## REMARKS

To make the present invention novel with respect to the citations, the applicant decide to cancel Claims 1 to 7, without prejudice or disclaimer of the subject matter thereof, and add new claims 8 to 14. The added new claim 8 is based on the original claim 1 and the features of Fig. 3 of the present invention. The new claim 9, 10, 11, 12, 13 and 14 add features same as the original claim 2, 3, 4, 5, 6, and 7, respectively, to the new claims 8. Thereby, it is assured that the new claims are based on the original claim and specification and thus no new matter is added. The relation of the new claims with respect to the original claims are shown in the following.

FIG. 1

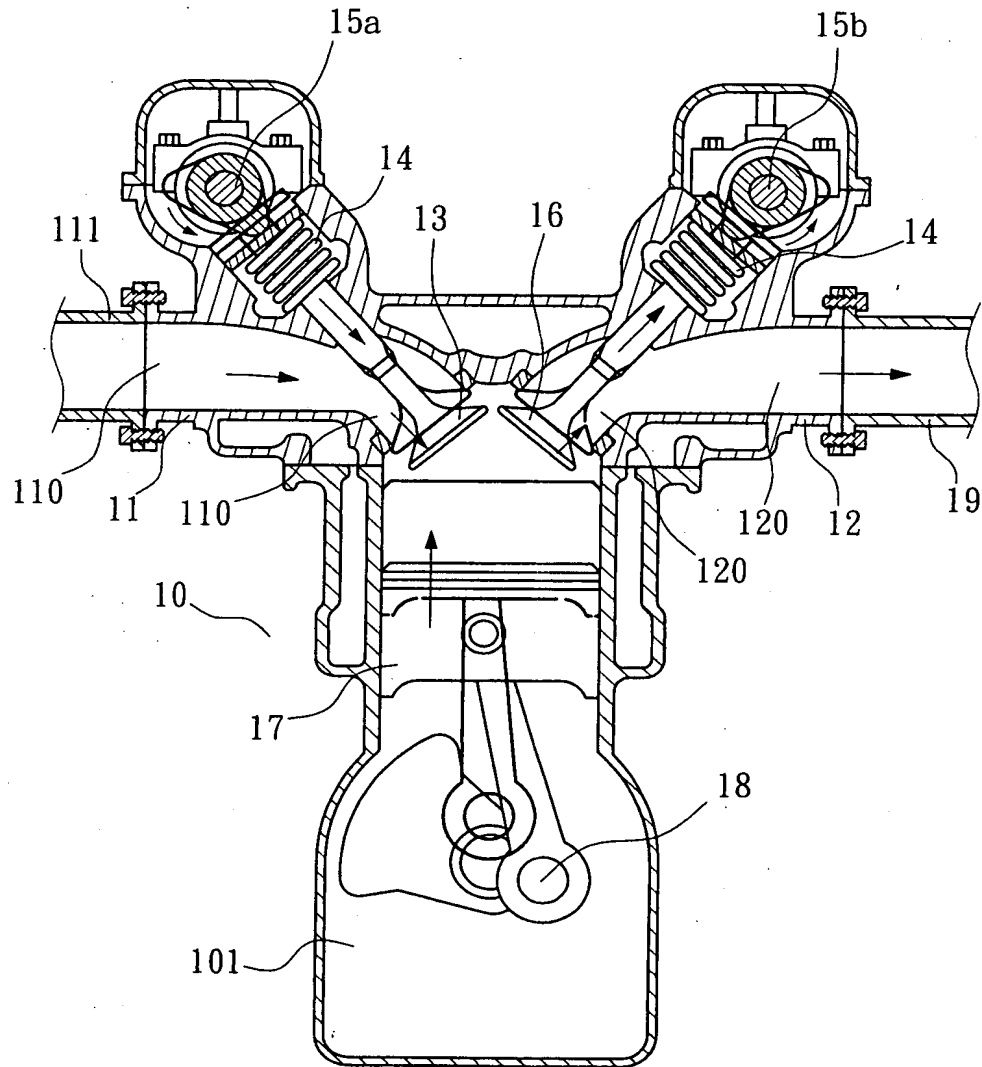
Please amend the Fig. 1 as the attached amended copy. In the amendment of the figure, the figure is added with "Prior Art". No other portion is amended. Thereby, no new matter is added.
